SITE PLAN REVIEW

LOT NO. 4 REGISTERED PLAN

CLIENT
HIGHCASTLE HOMES
PROJECT/LOCATION
**RIVERWALK, PHASE 2
BRAMPTON, ON**
DRAWING
SITE PLAN

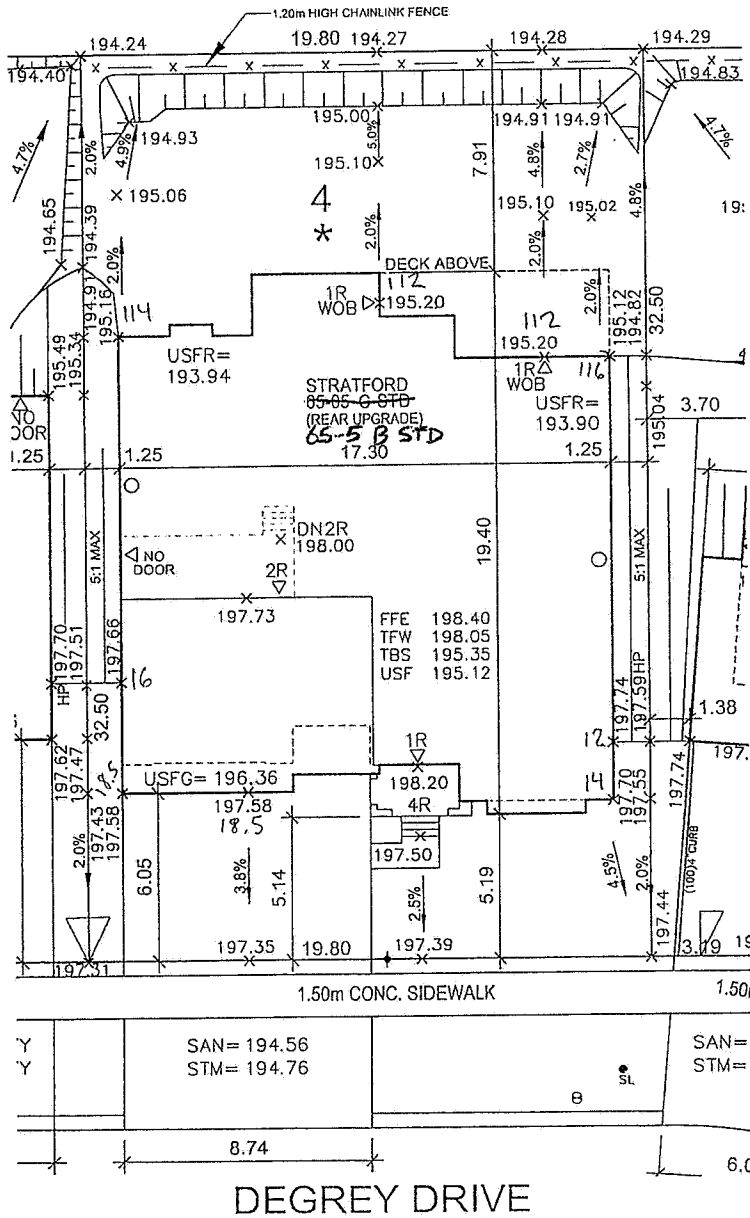
THE PROPOSED LOT GRADING AND DRAINAGE IS APPROVED AS BEING IN CONFORMITY WITH THE OVERALL APPROVED GRADING PLANS FOR THE SUBDIVISION.

NO COMMENT ☒ REVIEWED BY DL
COMMENTS AS NOTED ☐ DATE Jun. 20, 16
